ExxonMobil Former Buffalo Terminal Operable Unit 3 (BCP Site No. C915201D) Extension of Containment System at Babcock Street Combined Sewer Overflow Outfall

**Remedial Action Work Plan Addendum
(Long Term Corrective Measures Work Plan)**

**RE: ExxonMobil Former Buffalo Terminal OU-3 – Design of Sealed Sheet Pile Wall Extension
503 & 625 Elk Street and 1 & 3 Babcock Street, Buffalo, NY (BCP Site No. C915201D)
LaBella Project #2200012**

RE: Peer Review, Rev. 1
Permanent Sheet Piling Design
Elk Street Commerce Park
#220225.00

C201

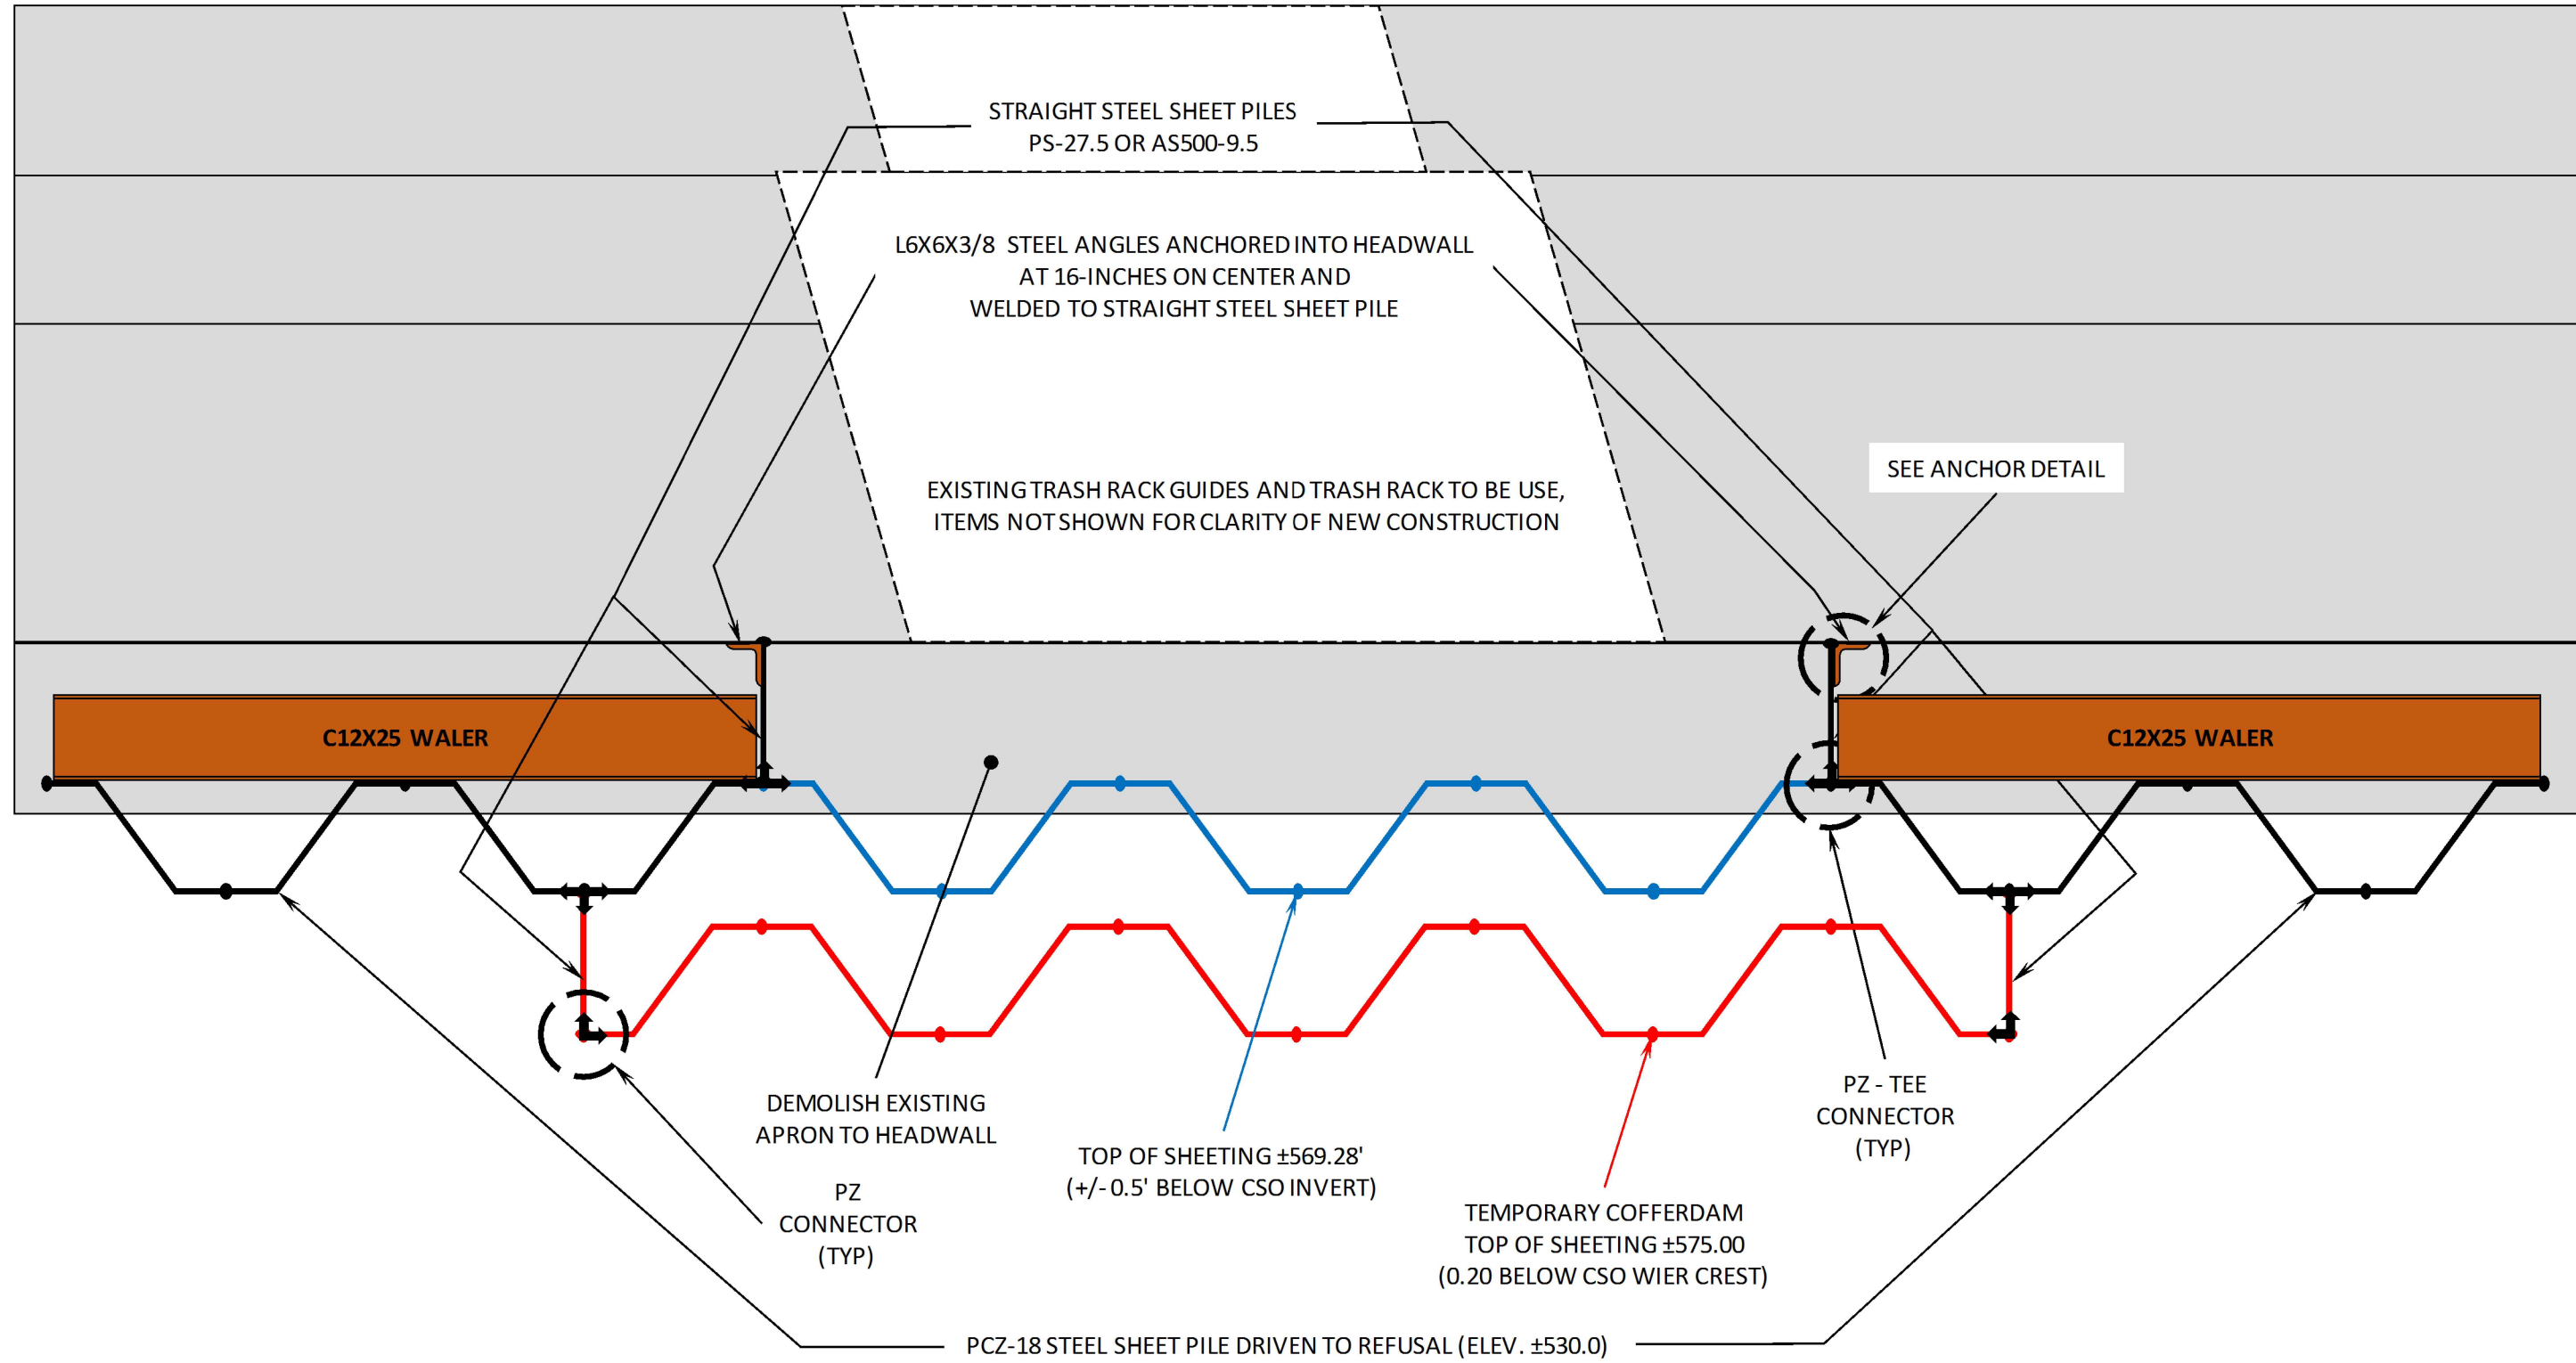
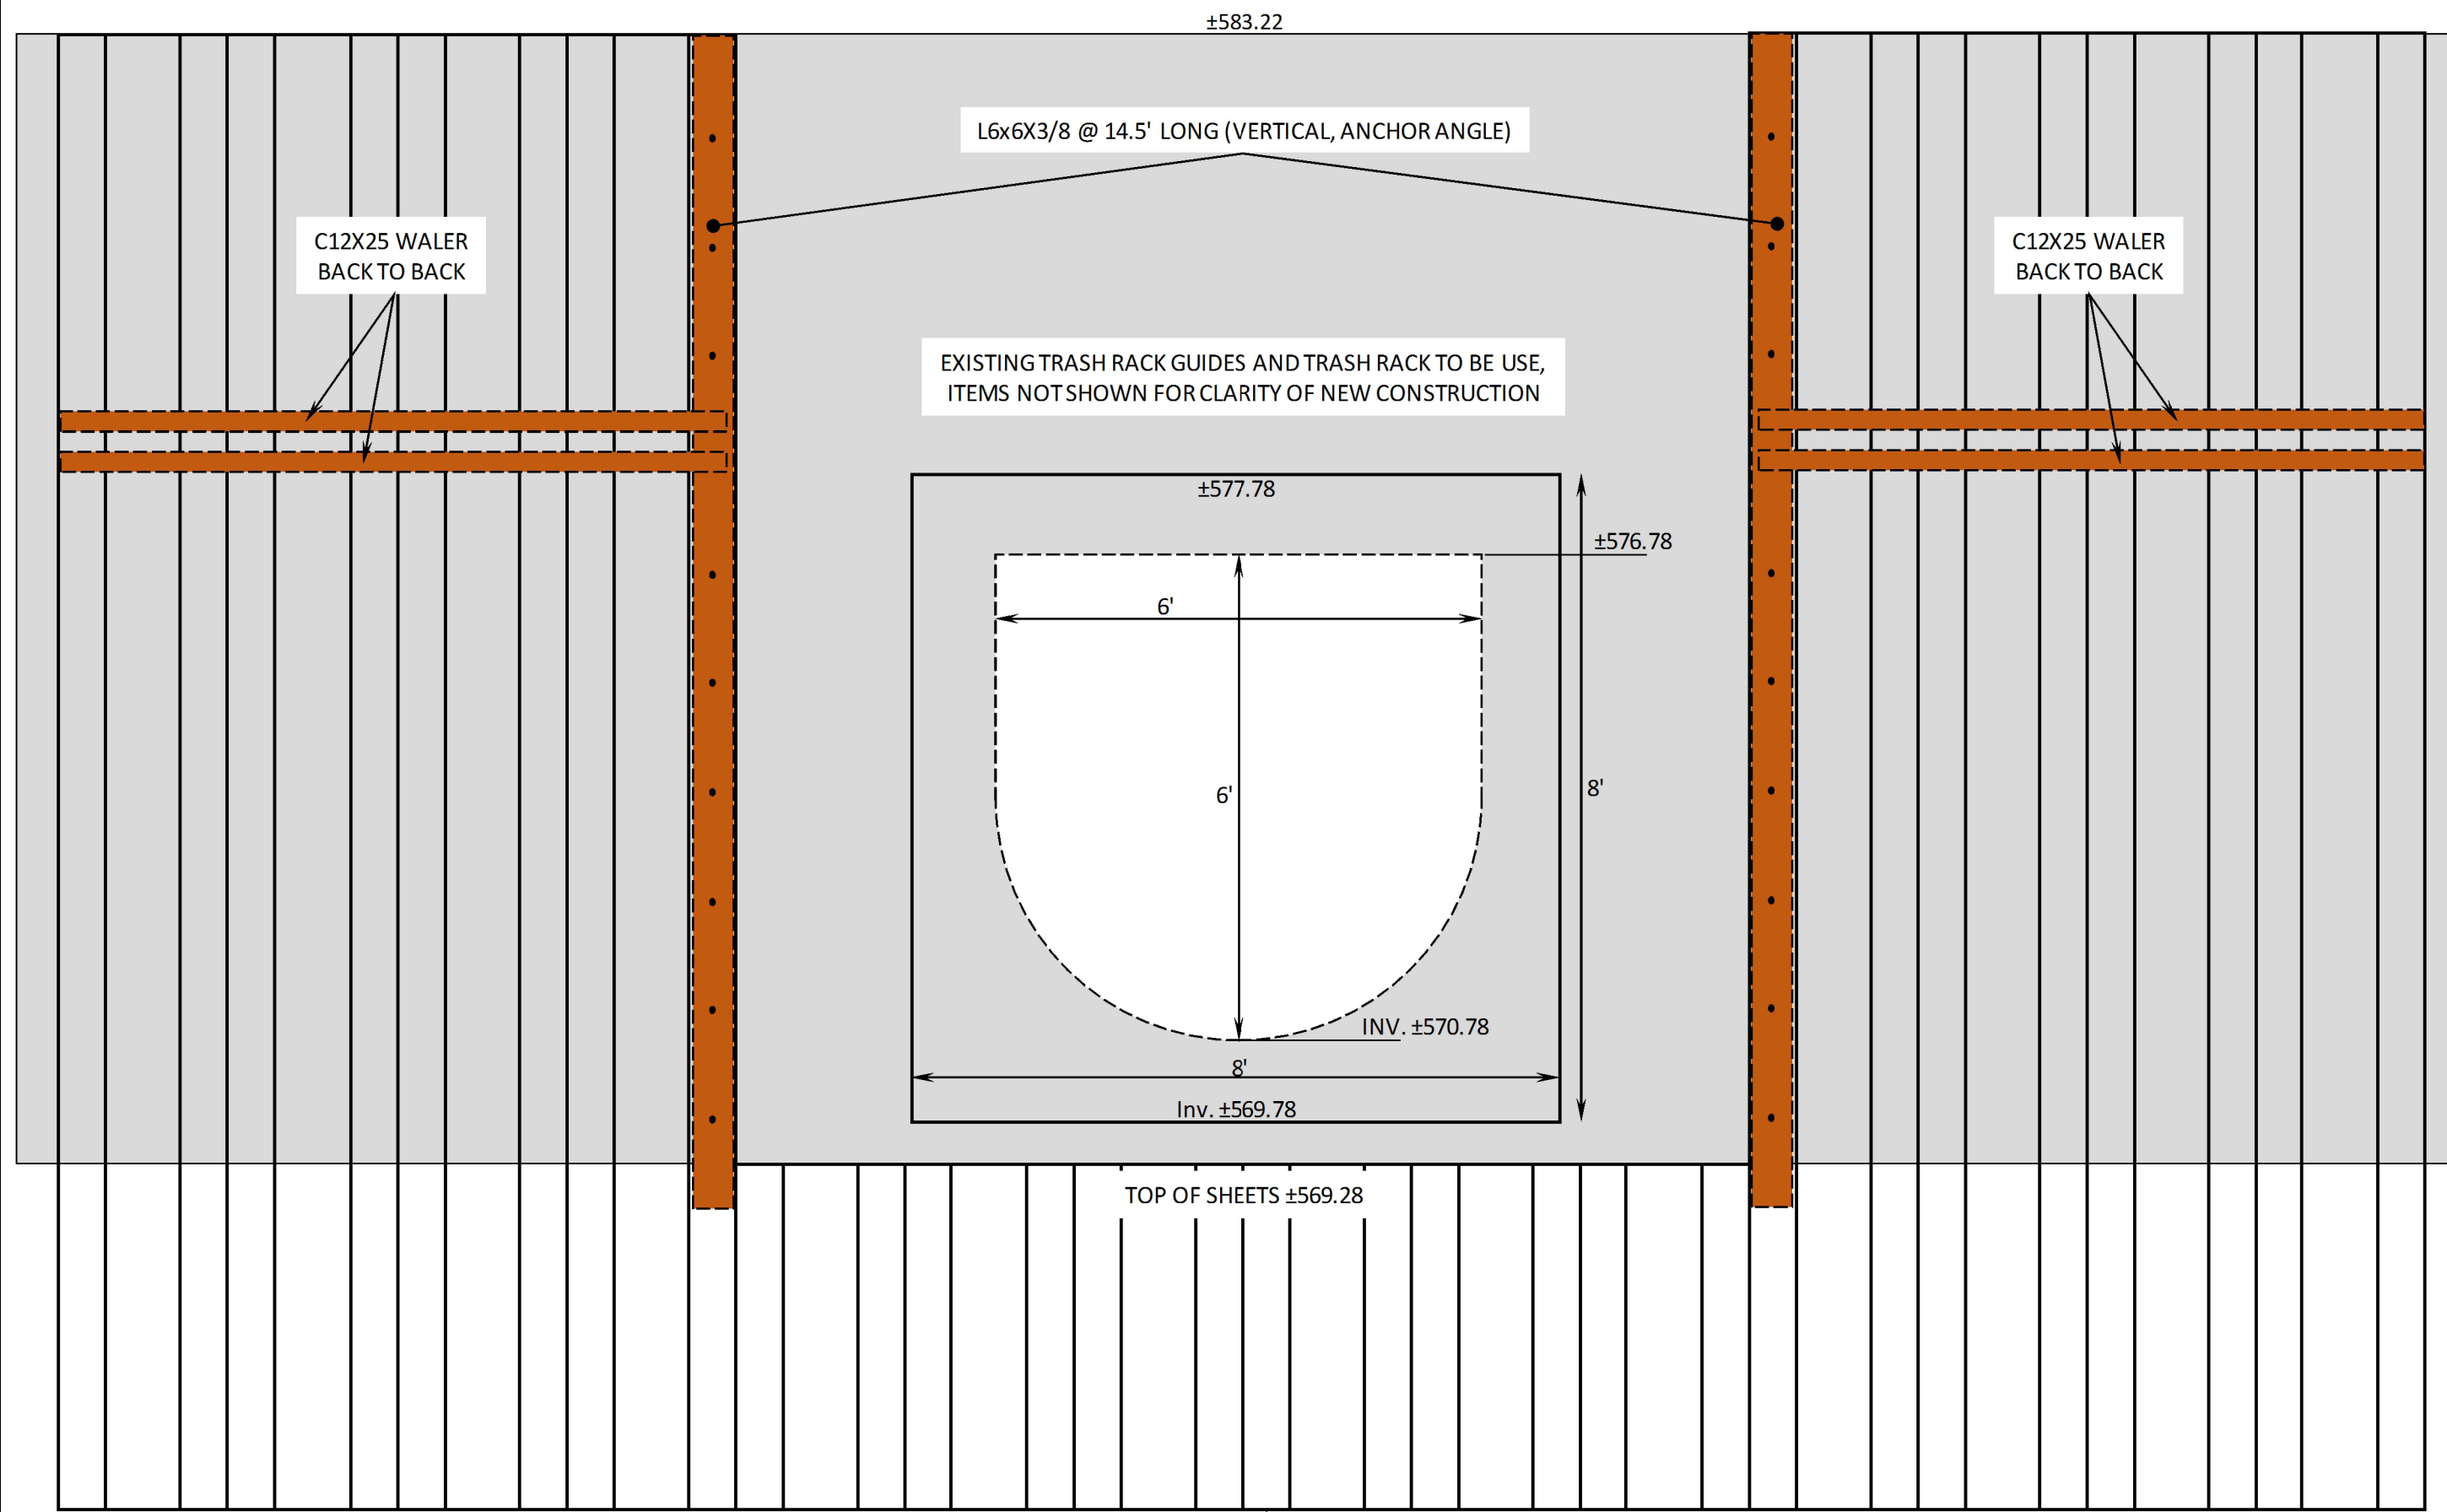
The SZC-16 Sheeting Piling in the hanging wall is adequate for use as the deadman anchor as shown by your red annotations on Sheet C-201, but will require a wale beam to distribute load.

8. The SZC-16 Sheet Piling in the hanging wall is adequate for use as the deadman anchor as shown by your red annotations on Sheet C-201, but will require a wale beam to distribute load.

A waler system has been designed for the Sheet Pile Bulkhead Wall and for the Deadman Anchor Wall (Existing Hanging Sheet Pile Wall) using:

BABCOCK DRAIN CSO WALER TO SCZ-16 CONNECTION DETAIL

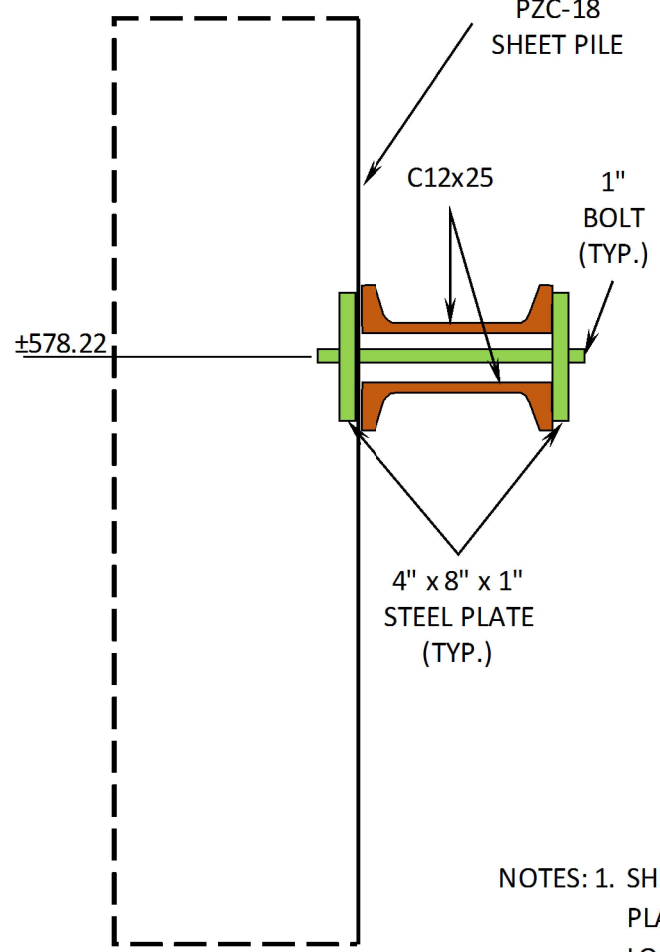
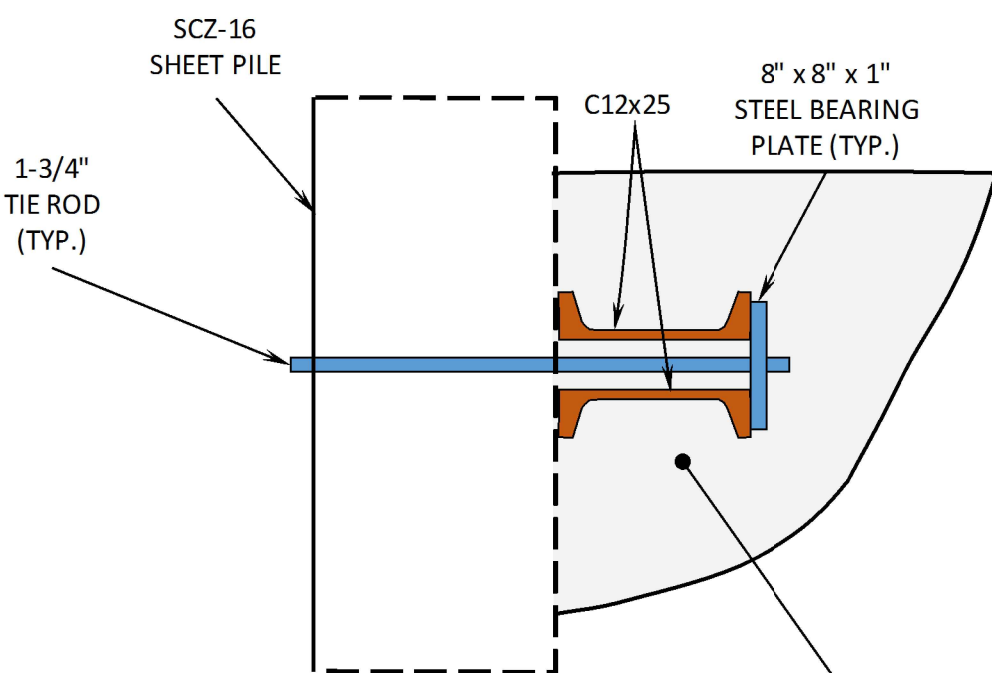
Tie rod design force of about 7 kips per ft. at 8-ft c-c spacing (56 kips) would be met with 1.5-inch-diameter grade 75 Thread Bar (or 1.375-inch diameter grade 150 Thread Bar) with an allowance for corrosion. Bar diameter could be increased or coated to provide additional corrosion allowance. Critical corrosion allowance should be considered at the exposed threaded connections.

A 1-3/4-inch diameter grade 150 thread bar has been specified to provide additional corrosion protection. To provide for critical corrosion protection at each end of the tie-rods, the tie-rod and waler shall be embedded in concrete.
